Access Compliance Report

Public Rights-of-Way

(Curb Ramps)

Intersection ID: 2549	Main Street: BEARDSLEY_DR	Cross Street: MCCHESENEY_DR	Location: S
ADA ID: 2F86D129ECA	Ramp Type: PerpDiag	Initial Pass/Fail: Fail	Overall Compliance: No
Severity Score: 12.5

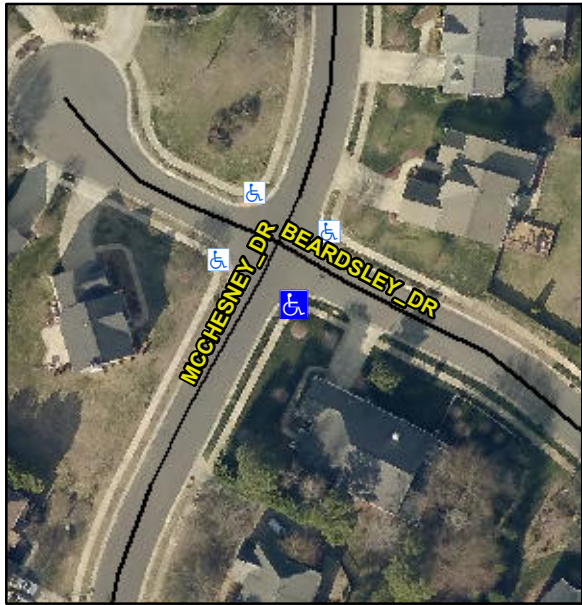
Codes/Mitigation Info/Possible Solution			Field Measurements/Component Compliance					
	Possible Solutions:		Compliance	Description	Data	Compliance	Description	Data
	Remove & Replace Curb Ramp With Two New Directional Ramps or Equivalent.		N/A	Ramp Length (in)	48.5	Yes	Ramp Slope (%)	5.3
			Yes	Ramp Width (in)	48.0	No	Ramp XSlope (%)	6.2
			N/A	Flare Type LT	N/A	N/A	Flare Type RT	N/A
			N/A	Flare Slope LT (%)	N/A	N/A	Flare Slope RT (%)	N/A
			N/A	Flare Traversable LT?	N/A	N/A	Flare Traversable RT?	N/A
	Surveyor Notes:		N/A	Landing Length (in)	N/A	N/A	DWS Provided?	N/A
			N/A	Landing Width (in)	N/A	N/A	DWS Contrast?	N/A
			N/A	Landing Slope (%)	N/A	N/A	DWS Length (in)	N/A
			N/A	Landing X Slope (%)	N/A	N/A	DWS Full Width?	N/A
N/A			Landing Curb? (Y/N)	N/A	N/A	DWS Offset (in)	N/A	
PROW/ADA:		N/A	Shared Landing?	N/A				
Not Found, R304.5.3		N/A	Gutter Ponding?	N/A	N/A	Gutter Slope (%)	N/A	
		N/A	Gutter Lip Ht (in)	N/A	N/A	Gutter X Slope (%)	N/A

N/A	Painted X Walk1?	No	N/A	Painted X Walk2?	No	
			X Walk 1 Direction	To NE		X Walk 2 Direction	To NW	
		N/A	X Walk 1 Width (in)	N/A	N/A	X Walk 2 Width (in)	N/A	
			X Walk 1 Slope (%)	0.2		X Walk 2 Slope (%)	5.5	
			X Walk 1 X Slope (%)	2.4		X Walk 2 X Slope (%)	1.5	
		N/A	Ramp inside XWalk1?	N/A	N/A	Ramp inside XWalk2?	N/A	
			Road Slope (%)	4.6	N/A	Clear Space?	N/A	
			Road X Slope (%)	2.7	N/A	Clear Space to XWalk (in)	N/A	
		N/A	Any Obstructions?	N/A	N/A	Storm Grate/Utility Hazard?	N/A	
			Obstruction Type			Storm Grate/Utility Type		
				N/A			N/A	
					Yes	Surface Condition? (G/P)	Good	
Total Cost:		\$	3200.00
